Eastern Regional Power Committee

Sub: Minutes of the 127th PCC meeting held on 22.06.2023

MINUTES OF 127th PROTECTION COORDINATION SUB-COMMITTEE MEETING HELD ON 22.06.2023 AT 10:30 HRS AT ERPC CONFERNECE HALL

220 kV Therubali Laxmipur -II

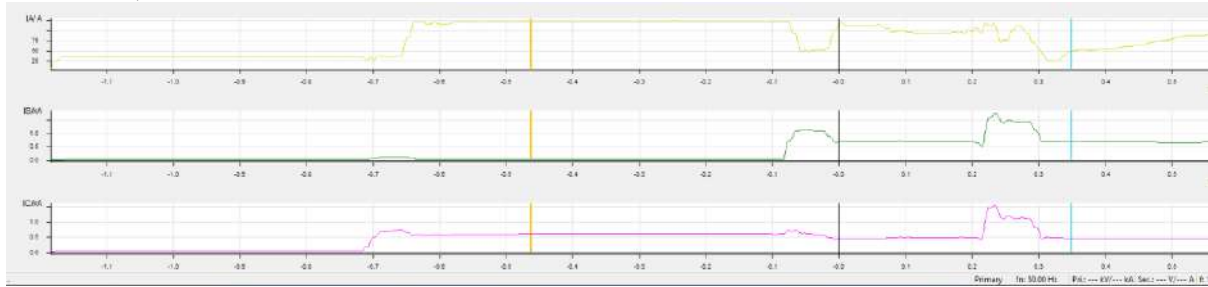
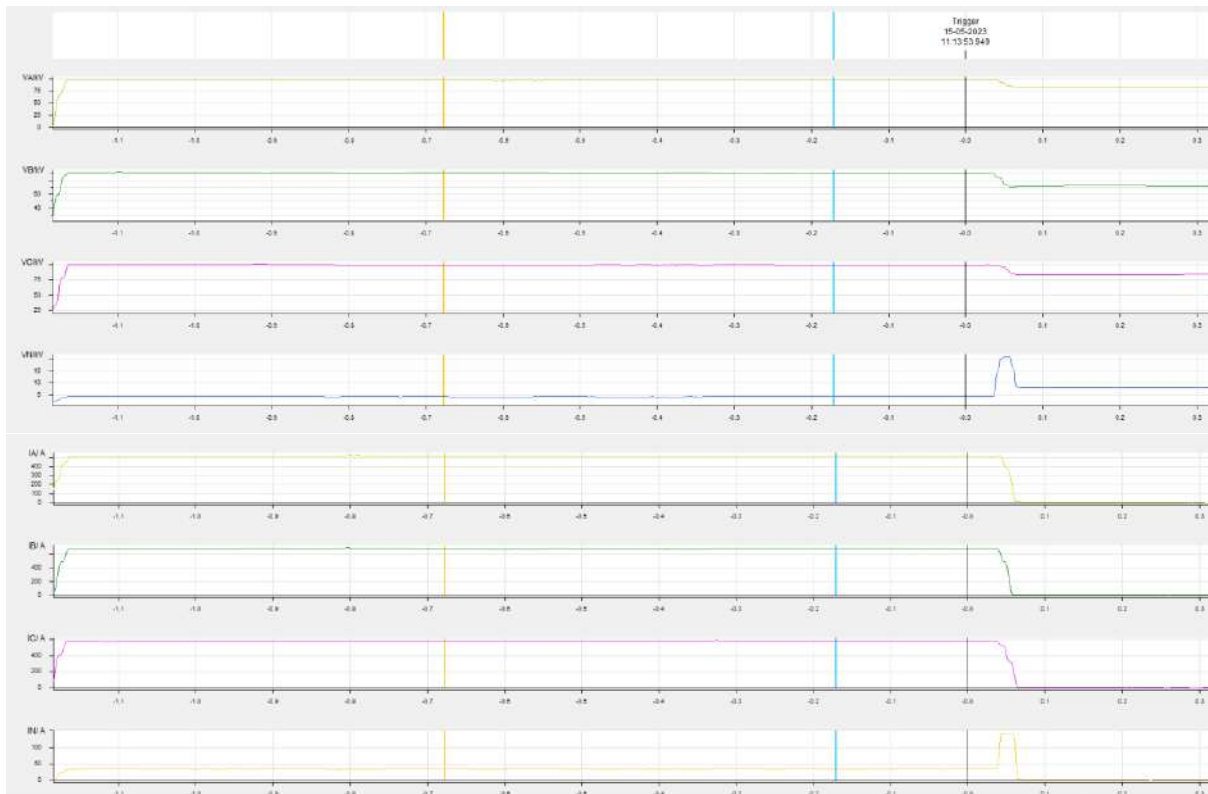
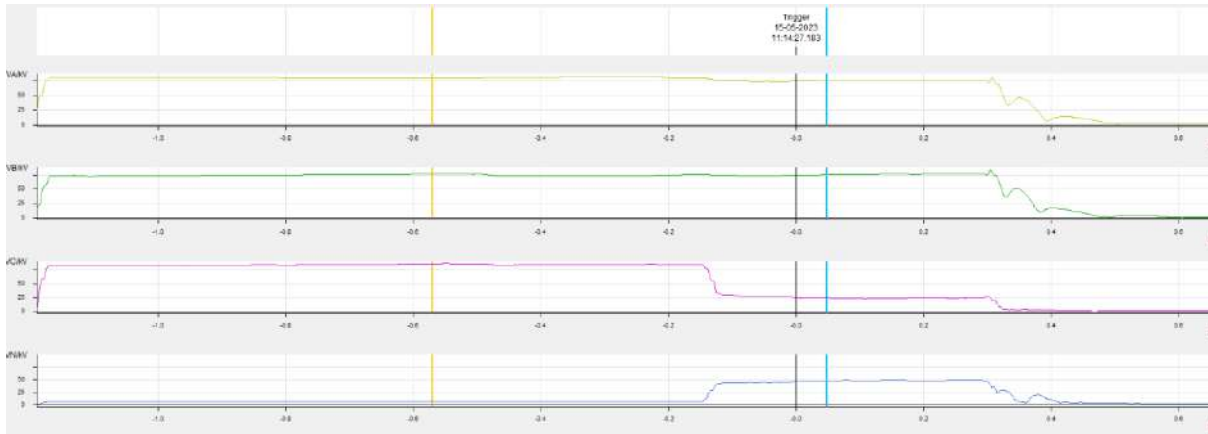
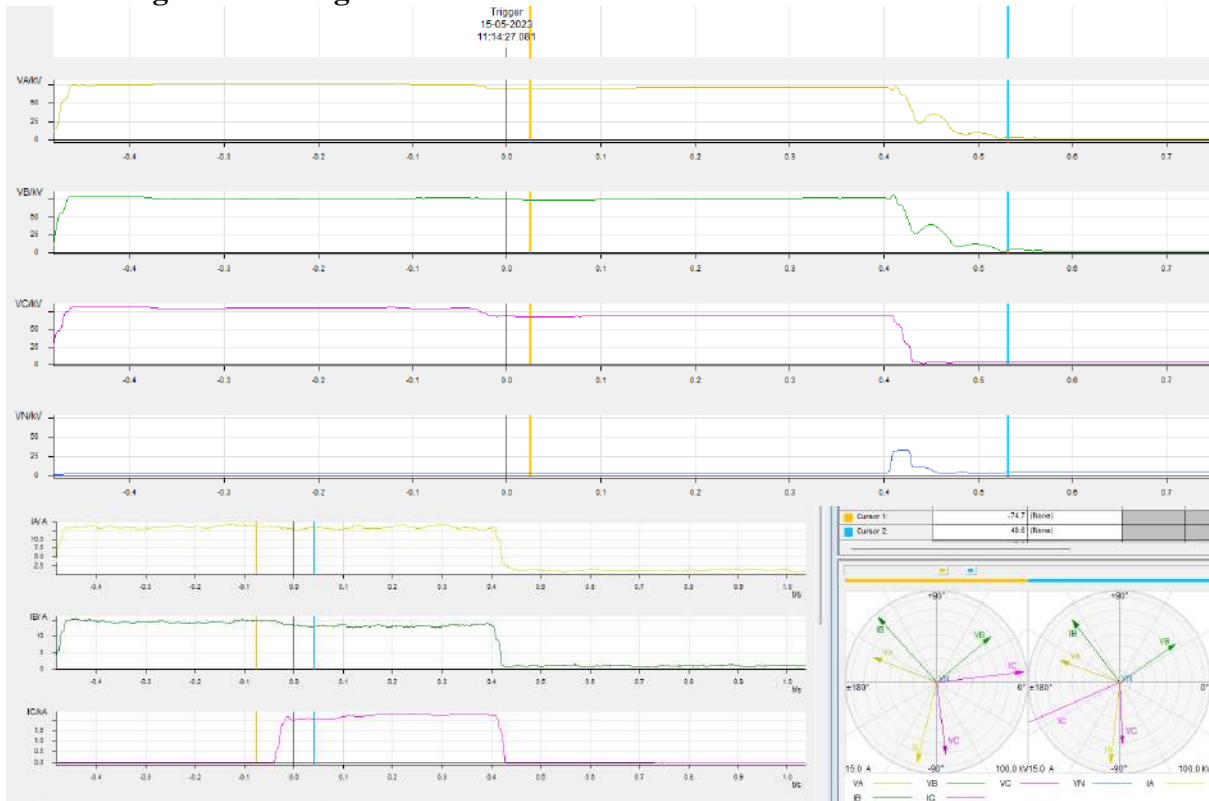
Ckt-2 tripped from laxmipur end in Zone -1. However, it seems three phase A/r in in service and there was single phase trip during successive fault within A/r dead time.

At Therubali end, fault was not cleared due to non-tripping of its main & tie CB at Theruballi GSS end. It was found that the DC supply failed in its own CR panel due to blown control circuit fuse. On further checking, it was found that the spring charge indication bulb terminal shorted in its main CB due to which control fuse got blown.

11:13:53:943 at T+11: Laxmipur end :Y-B phase fault and F/C , 600 amps and IN=600 Amps persisted for 11 seconds and line tripped from Laxmipur end after 11 seconds Line current zero but line voltage was persisting which means breaker was closed from Therubali end .Tripped on I>1, why it took 11 seconds to operate , Overcurrent protection setting to be checked , and if DEF enabled it should have also operated, both things to be checked.

If breaker tripped from laxmipur how it got path to feed current in reverse even if both lines touch via opgw snapping fault current path should be forward to Therubali.

Line is 65 Km and Z-4 distance in relay is 41 km, this may be checked as z-4 reach seems to be set at higher much higher.

1. Control ckt of main CB of 220 KV Theruballi-Laxmipur Ckt-2 rectified.
2. Zone-4 time delay setting set at 500 ms in all DP relays of 220 KV system at Theruballi GSS.
3. Existing CR panel scheme is very old and there is no provision of Trip coil supervision, DC supervision and Ann. facia with existing scheme.
4. So necessary scheme modification will be done to adopt above supervision.

Laxmipur-2 feeder Main Breaker (Siemens) at Theruballi GSS

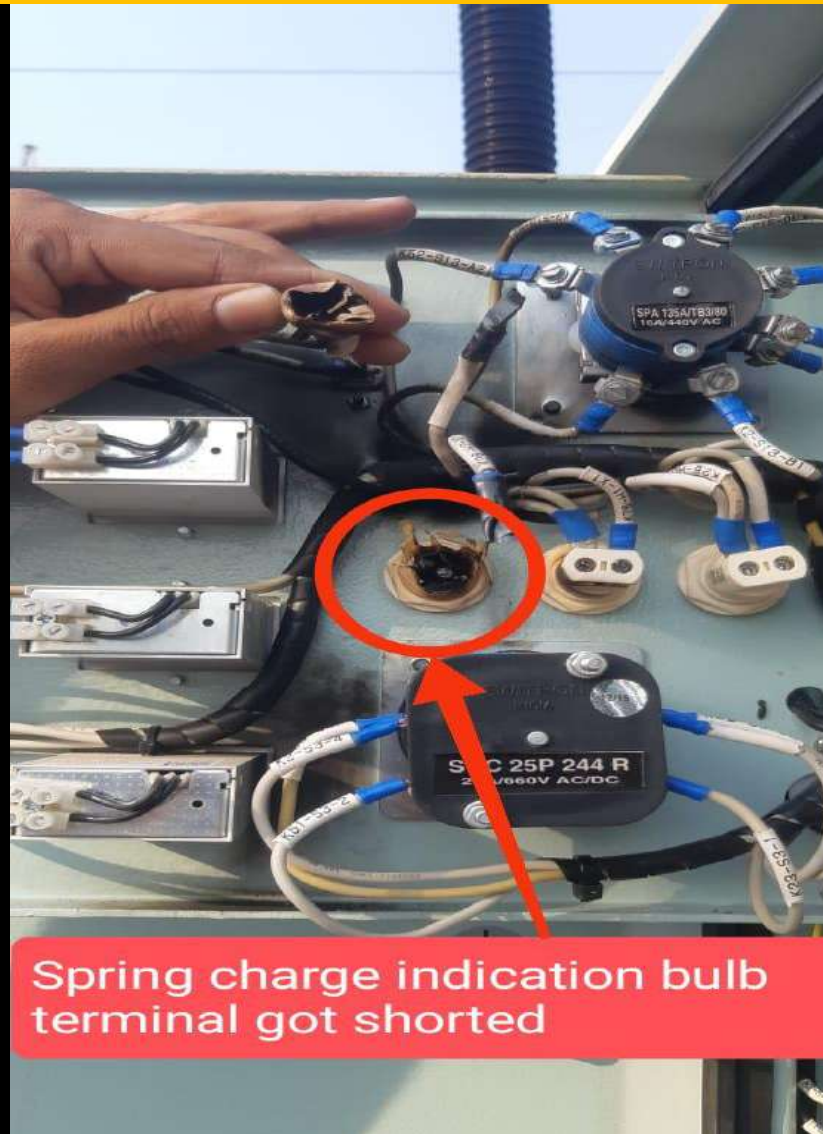
Main and tie CB of 220 kV Therubali-Laxmipur-2 at Therubali end did not operate during the fault in the line. On detailed investigation it was found that spring charge indication bulb terminal got shorted in the main CB which caused fuse blown of control circuit in CR panel and resulted in failure of DC supply to the panel. This ultimately led to non-operation of breaker. OPTCL representative explained that as the fault current feed by individual 220kV feeders i.e Upper Kolab/Indravati 1,2 3& 4/Bhanjanagar 1&2/ Narendrapur 1 &2 is very less, so fault continued upto 70 sec due to delay in fault clearance from ends.

Spring charge indication bulb terminal got shorted

Reason for Busbar tripping

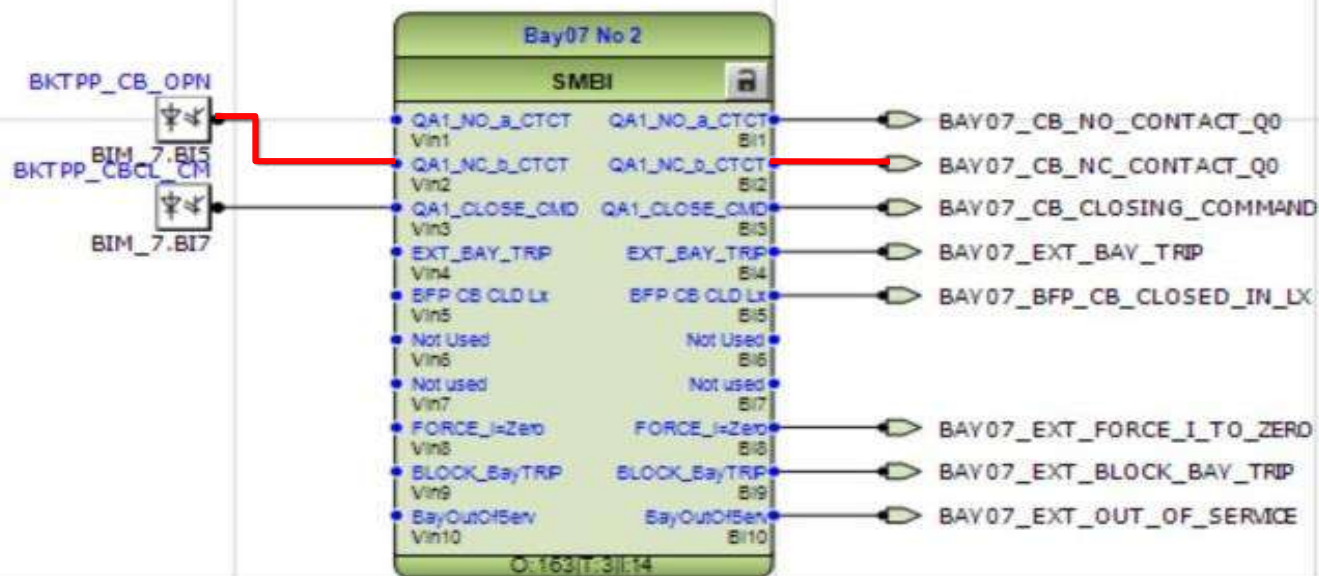
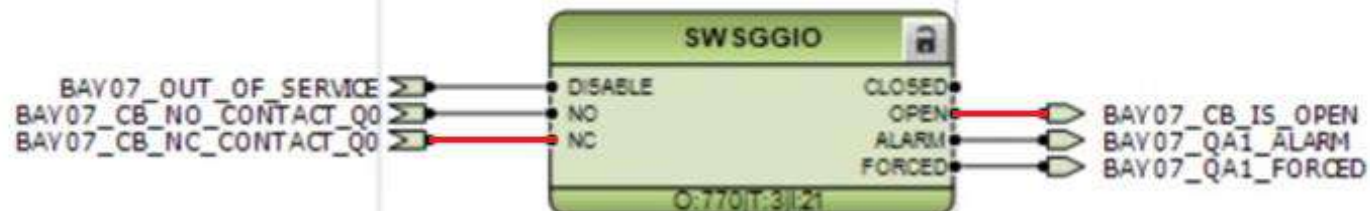
- CB open status stays during charging of BKTPP bay.
- CB close command did not come.
- As per relay configuration , current fed by BKTPP bay during charging(4.6 KA) could not be counted to BUS B.

- ▣ CB close command was checked and it was found CB discrepancy switch Close Contact for Busbar relay was found faulty.
- ▣ CB Discrepancy switch will be replaced upon getting shutdown.

Disturbance at Lapanga, OPGC at 17:27 hrs on 10.06.2023

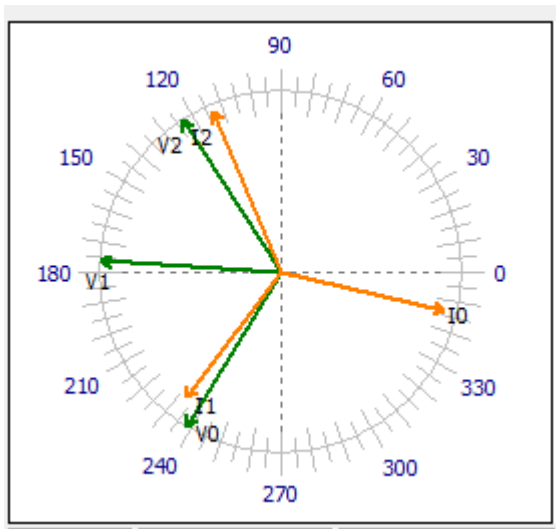
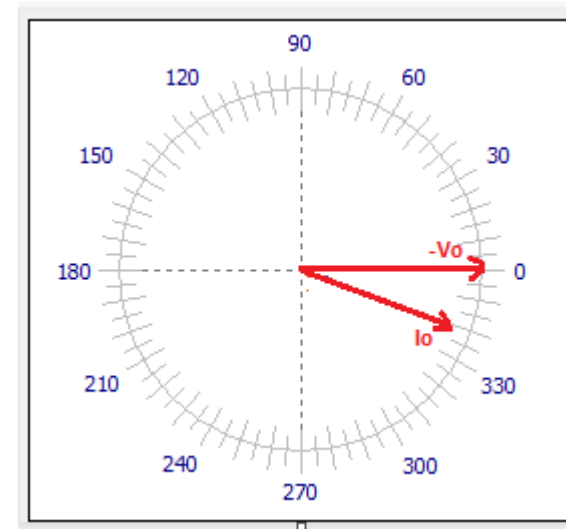
It was observed that instead of sufficient fault current, neither distance protection nor DEF operated for 400 kV Meramundali-Lapanga-1 at Lapanga end due to which fault got persisted for 17-18 seconds and led to tripping of other feeders from remote end.

At 17:25:56-Charging attempt of 400 kV Meramundali-Lapanga-1 taken from **Meramundali**. Distance protection (Y_B_N) operated instead of SOTF and line tripped.

At 17:26:54- Charging attempt taken from **Lapanga** end, however, no protection operated, and fault persisted for around 17-18 seconds.

- Charging attempt from another end immediately after failure from one end
- No protection operation at Lapanga. Fault current was also sufficient. From Back UP DR also, it seems fault was seen in forward direction but neither distance nor DEF picked up.

PCC advised OPTCL for root cause analysis of the event and a report along with DR/EL shall be submitted to ERPC/ERLDC. The issue would be discussed in next PCC Meeting.
